CABINET MEMBER FOR ENVIRONMENT – 16 JULY 2020
OXFORD: CENTRAL AREA – PROPOSED ADDITIONAL CYCLE
PARKING PLACES

Report by Interim Director of Community Operations

1. The Cabinet Member for the Environment is RECOMMENDED to approve proposed additional cycle parking places in central Oxford on New Road, Speedwell Street, Wellington Square and Ship Street.

3. This report presents responses received to a statutory consultation to introduce additional cycle parking places in Oxford city centre at New Road, Queen Street, Ship Street, Speedwell Street, Turl Street and Wellington Square.

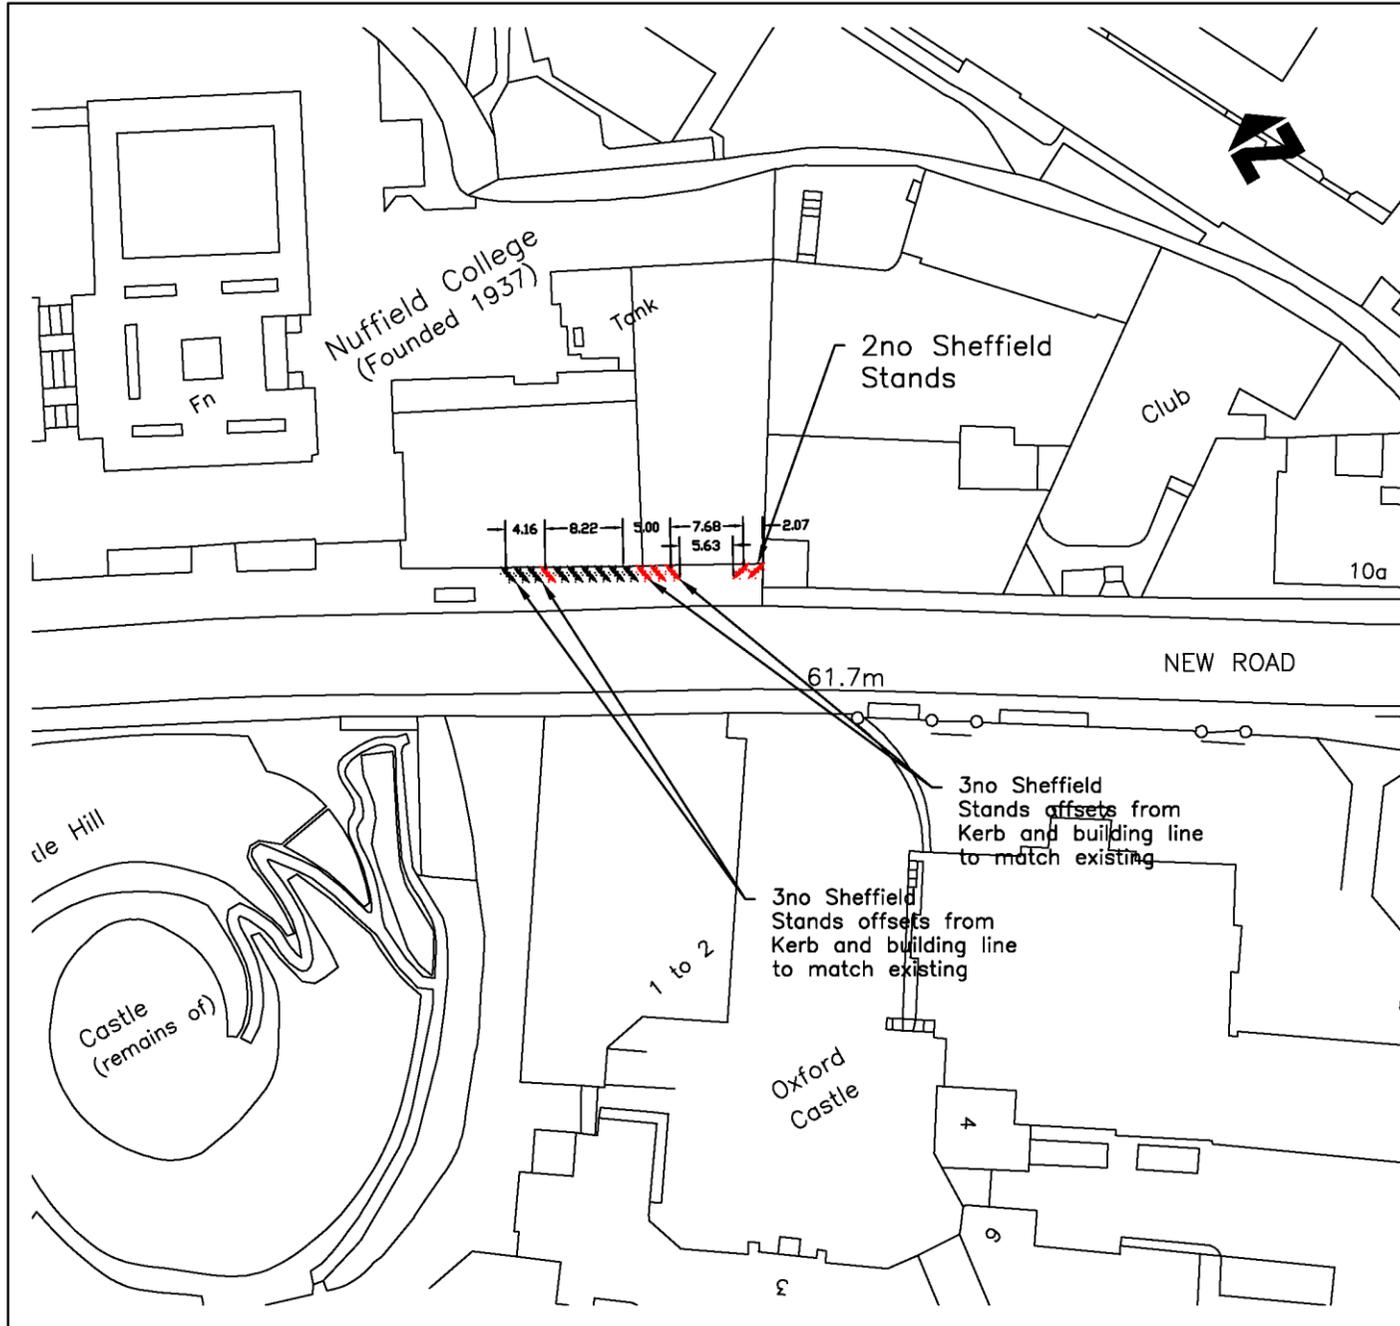
8. There were some concerns that the proposals here were only adding a small number of new stands and that spacing would be inadequate. To clarify, the existing toast rack provision would be replaced with more permanent root fixed stands in an echelon formation to maximise footway space. Together with the two new stands shown to the east of the adjacent vehicle entrance there would be an additional 6 bicycle parking spaces. Spacing would be a minimum of 1m between stands (measured perpendicular to the stands).
9. Cyclox objected to the proposals for New Road but it appears from the photo used in its response that there is some confusion about the location. The proposals are in fact further up New Road to the east.

(a) New Road – extend/increase the existing cycle parking on the northeast side outside of Nuffield College,

Cyclox objects to the detailed location and design.

The proposed provision neither extends nor increases the provision.

- **Cyclox objects to loss of the convenient right-angled positioning for the cycle-parking spaces,**
 - What is the reason that this has been changed to echelon stands?
 - There is an ample 'forecourt' and off-the-footway space.
- Echelon is likely to lessen the usability of better-spaced stands at right angles.
 - Four stands in 4.16m is likely to give a 1.07 spacing at right angles.
 - This is inadequate and should be 1.20m at a minimum.
- And why only 15 stands to replace the 17 in the StreetView photo?
- What is the reason for the 5.63m gap? There is no doorway here, for practicality but there is a degree of symmetry in the arrangement.

- The easternmost stand in the proposal is mounted too close into the corner so it is limited in its utility.

**Location of Cycle Racks
Detailed Layout – Queens Street**

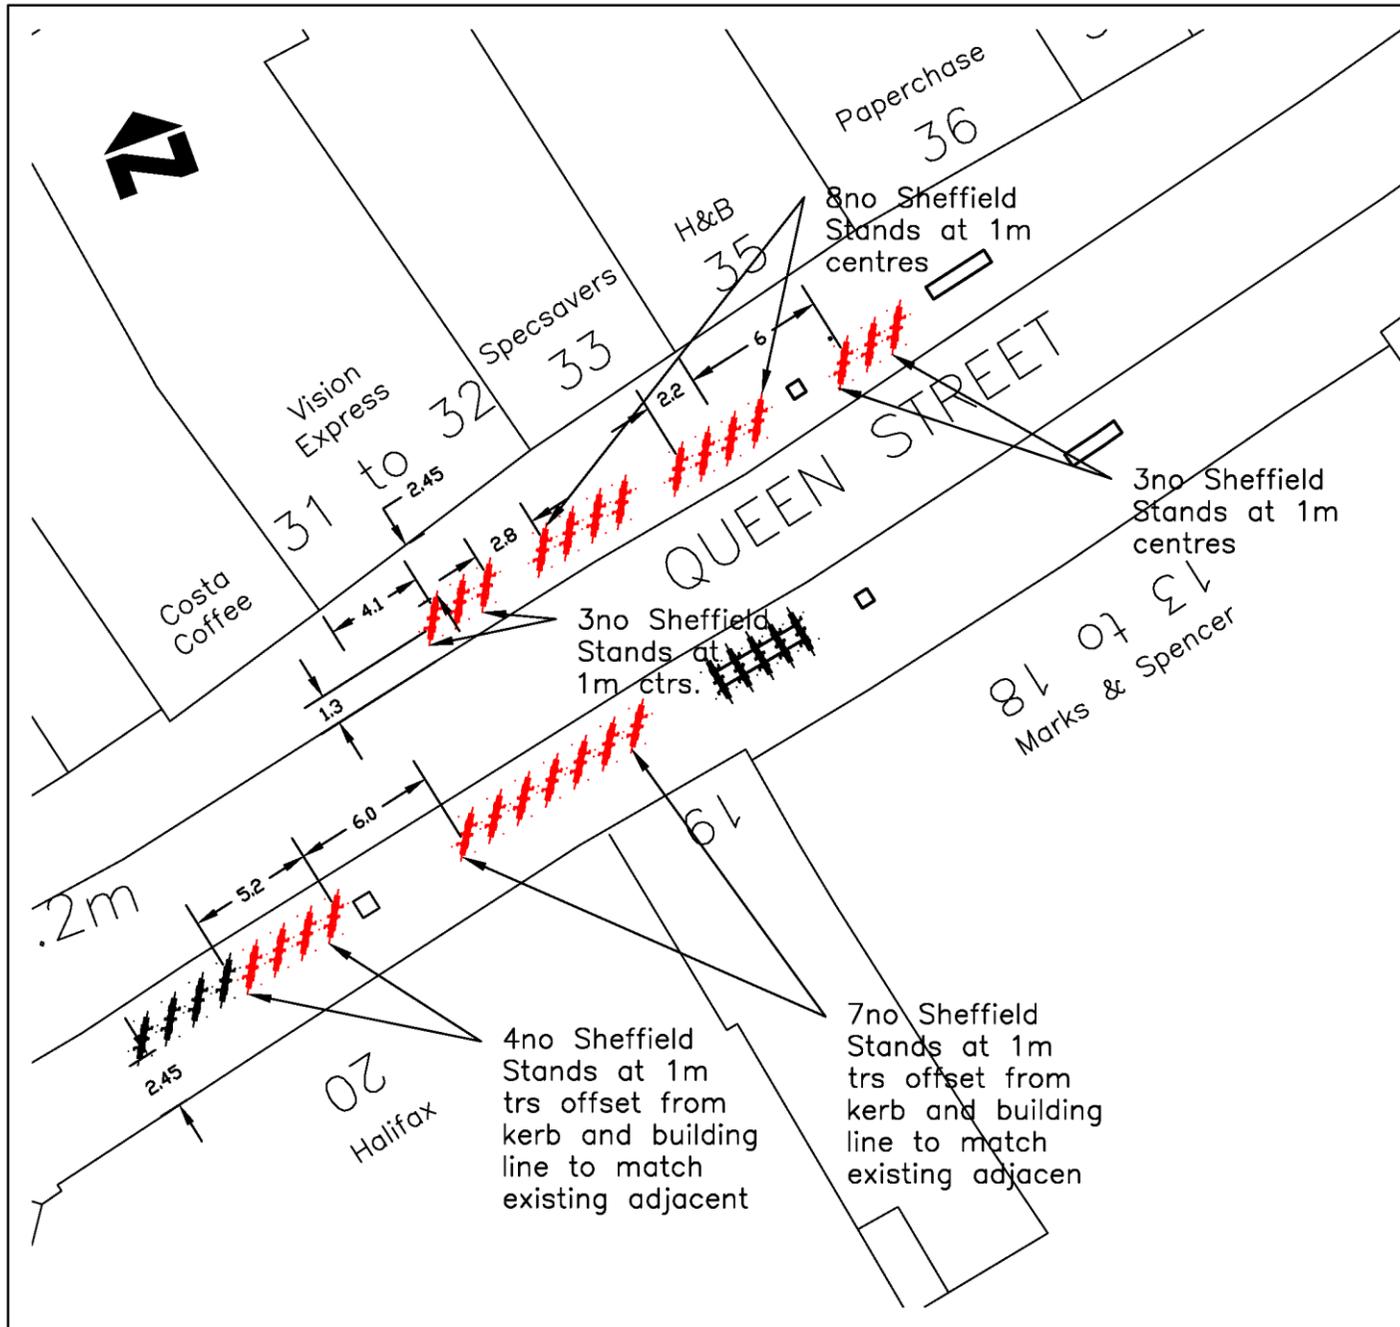
10. These proposed new stands attracted a number of comments – both positive and negative. Some felt that this was a good general location due to it being close to places people would want to cycle to. Others felt it would be inappropriate not just because cycling is prohibited during the day (users could though push their bikes to the stands from Carfax or Bonn Square) but more significantly because of how busy the street will become again once Covid-19 lockdown restrictions are eased further. Officers feel that on balance the proposals should not be implemented at the current time due to the need to encourage free flow of pedestrian movement along and across the street, enabling better social distancing.

(b) Queen Street: – introduce 7 new sections of additional cycle parking on: a) the north side outside Nos.31-35, and b) south side outside of Nos.13-20,

Cyclox objects to the detailed location and design.

1. The locations take from footway space.
 - a. There is no kerb in this level-surface street.
 - b. The black-strip marked carriageway is some 5.00 metres wide. 2.75m is adequate for one-way, slow-moving bus traffic.
 - c. Stands should be located closer to the ‘carriageway’ or astride it.
2. The design of proposed stands at 1.00m centres, in echelon formation, means that inadequate spacing exists between the stands.
 - a. This arrangement is a ‘false-saving’ and needs to be redesigned at or near to right angles with a 1.2m spacing.

The cycle parking should go up to or across the dark stone and not to treat that line as a kerb. There is an issue regarding the number of spaces to put into any block of bike-parking.

**Location of Cycle Racks
Detailed Layout – Ship & Turl Streets**

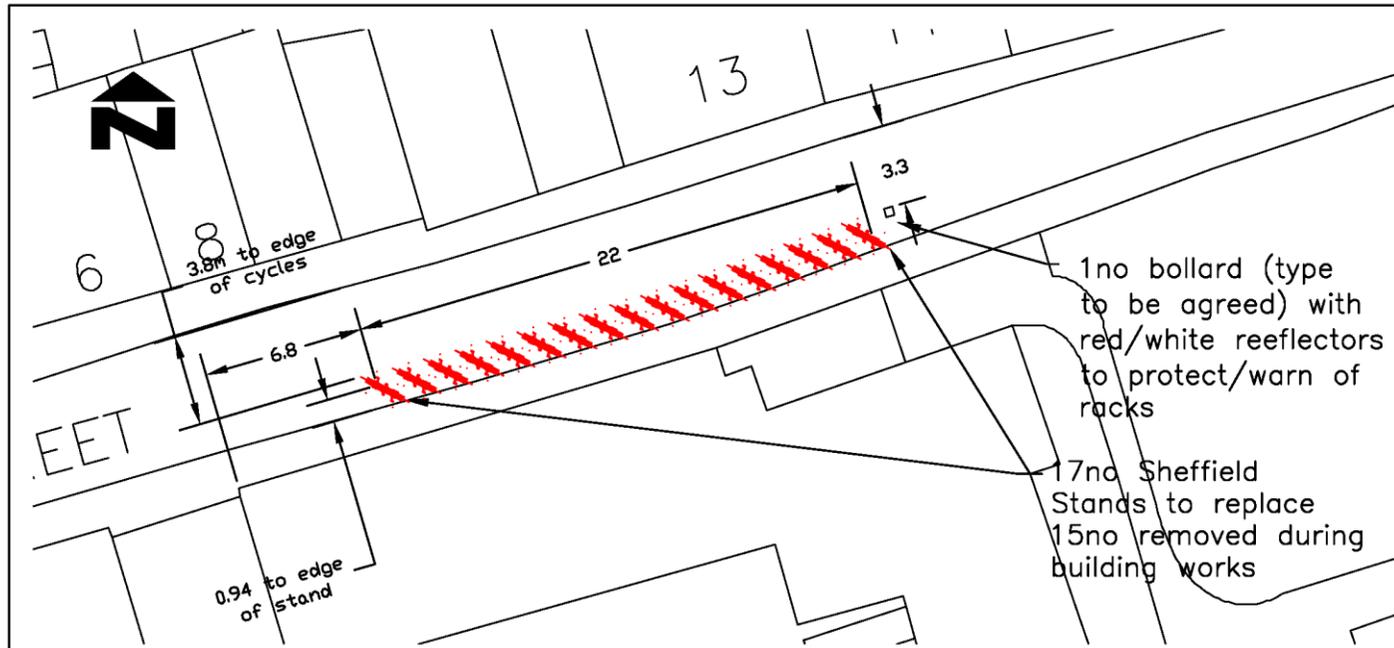
11. Fifteen Sheffield stands perpendicular to the carriageway have been removed temporarily to accommodate building work at Jesus College. The proposal here is

to replace these with 17 stands at an angle to the carriageway when the building work is complete. Cyclox wants to see the racks replaced perpendicular to the carriageway with a further 10 stands to the east. The stands are proposed to be replaced at an angle to maximise the amount of cycle parking space due to the fact that the carriageway narrows to the east. It is not felt that the road is wide enough to add 10 more as Cyclox suggests, even with the stands at an angle. On site, during the work, engineers will double check if (i) the racks can be replaced perpendicular to the carriageway after all and (ii) more than 2 new stands can be provided whilst allowing safe passage of vehicles. All stands will be replaced with minimum spacing of 1m between stands (measured perpendicular to the stands).

13. A number of people commented that the proposed stands would restrict and inconvenience pedestrian flow. Officers agree and recommend that these stands are not installed.

Cyclox objects to the design.

- 1) Cyclox objects to the use of an echelon formation here
 - a) The outcome, particularly at the reduced spacing will be less convenient bike parking.

3) Cyclox proposes that the additional 10 stands in the earlier proposals are provided here.

1. The four proposed for Turl St, near the Brasenose Lane corner, will be in the pedestrian walkway and thus they are poorly located.

2. Cyclox objects to the use of an echelon formation here
3. The outcome, particularly at the reduced spacing will be less convenient or even unusable bike parking.
- 4) Cyclox proposes that the cycle parking is located on the 'apron', associated with the rising bollard, enabling a continuous path for pedestrian traffic adjacent to the College wall.

**Location of Cycle Racks
Detailed Layout – Speedwell Street**

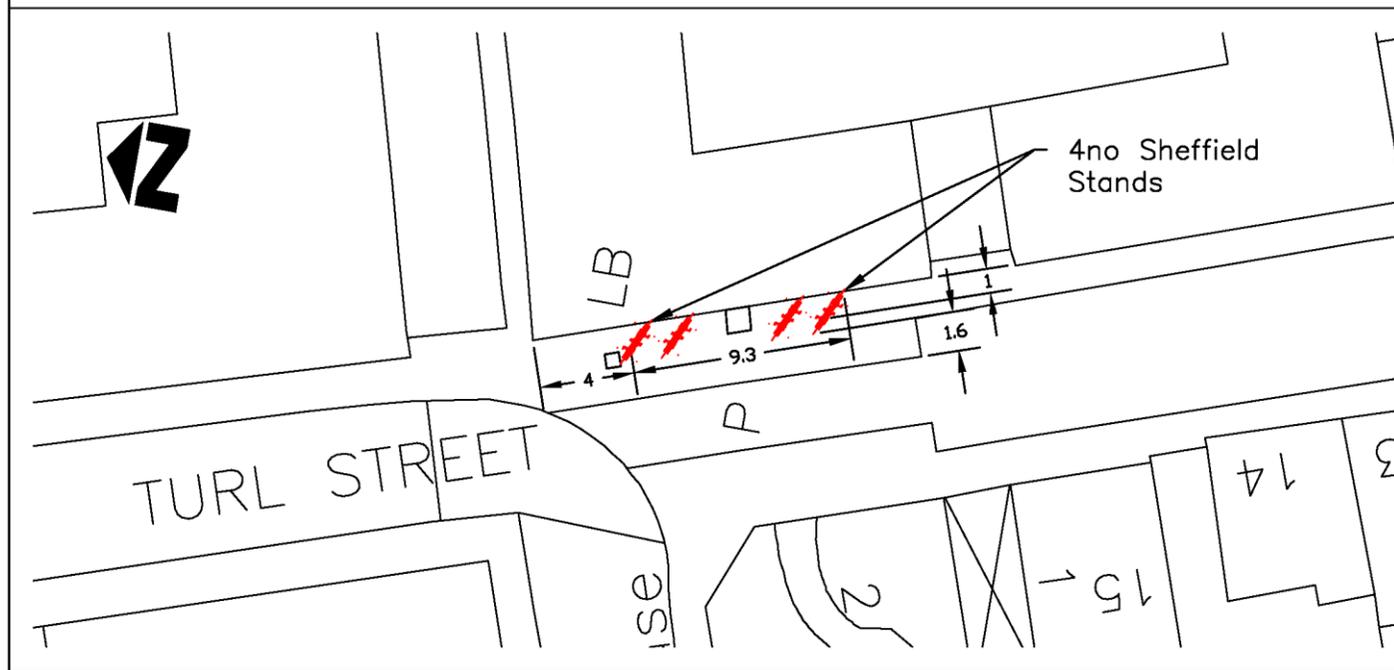
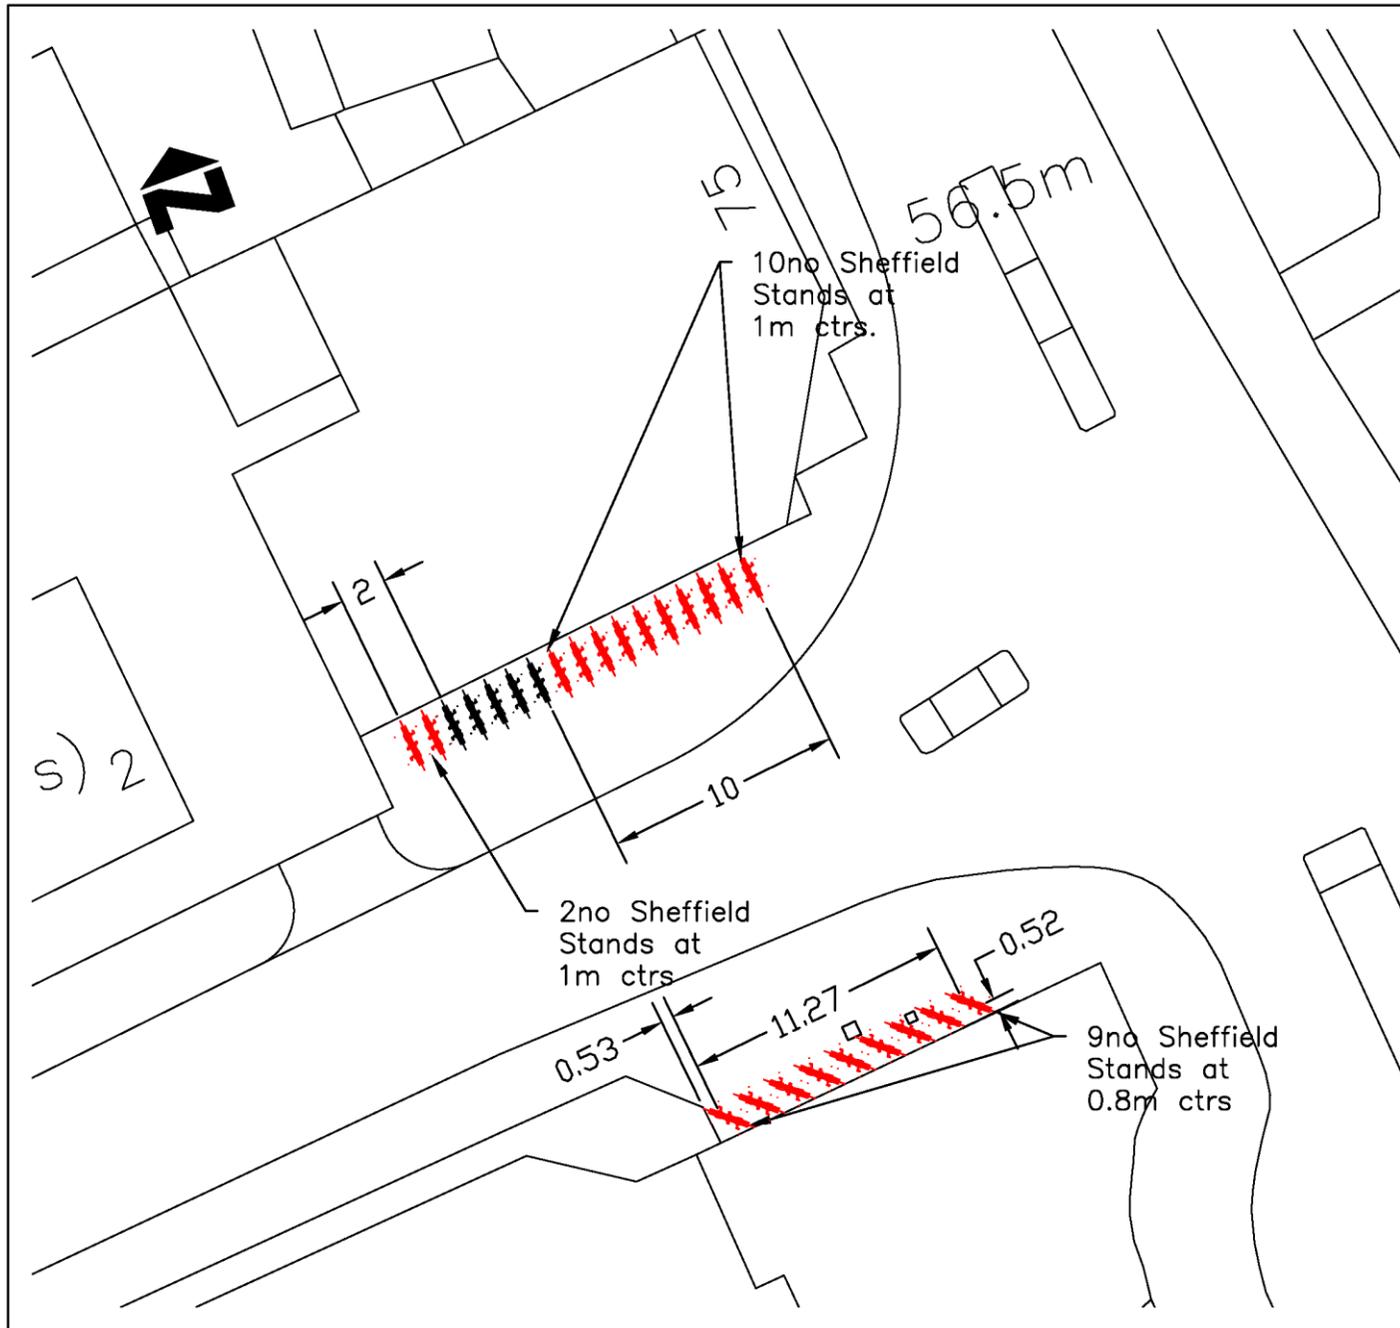
12. Concern was expressed that 0.8m spacing of the stands on the south side of the street is insufficient. Officers agree and recommend that these stands are spaced at 1.0m. If it is possible to place them perpendicular to the building this will be done. On the north side, Cyclox suggest that space is provided for hire bikes apparently on the basis of a Google Streetview photo. There are now very many fewer dockless hire bikes than when the Streetview image was taken but in any case, officers recommend that space is provided only for the general public, not hire bikes. Officers agree that spacing here between stands can be 1.2m due to there being more space generally and lower pedestrian flows.

Cyclox objects to the design layout.

- 1) Cyclox objects to the use of an echelon formation at the south side of Speedwell St.
 - a. Cyclox objects to the reduction from 12 to 9 stands.
 - b. Cyclox proposes an increase as in the 'Oxford City Centre Cycle Parking Audit, 2018', which proposes: "Install 12 x Sheffield stands, perpendicular to the wall, as indicated ...".
 - c. The proposal to locate these stands at 0.8m centres means that an unusable dimension will be available between the stands,
 - d. we propose 1.2m spacing.
- 2) Cyclox is concerned at the spacing on the north side of Speedwell St, at 1.0m. We propose 1.2m for convenience.
- 3) Cyclox proposes double-level storage and shelter in both these locations.
- 4) Northside, adjacent to Tescos, on Streetview this 'space' is filled with Hire Bikes –
 - a. Cyclox suggests that Hire Bike spaces should be provided.

**Location of Cycle Racks
Detailed Layout – Wellington Square**

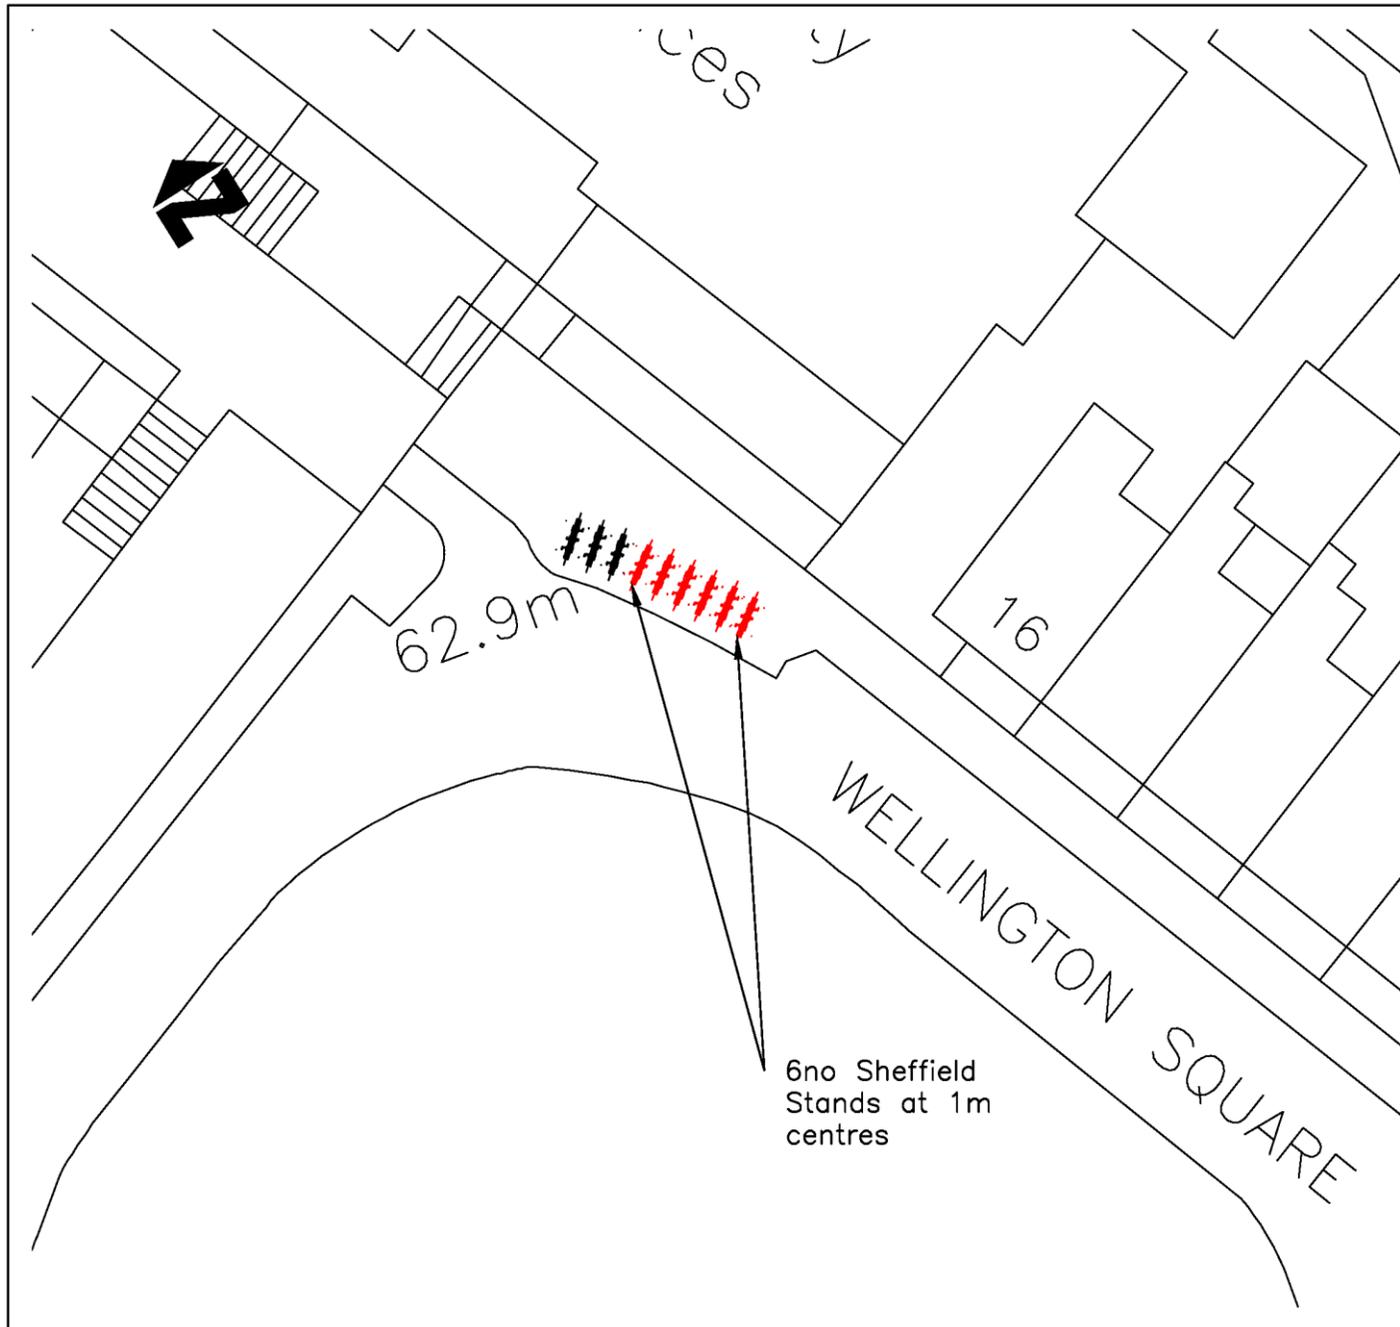
14. There were no objections to the proposed additional bicycle parking in Wellington Square.

Cyclox comments that the additional stands seem to be well placed.
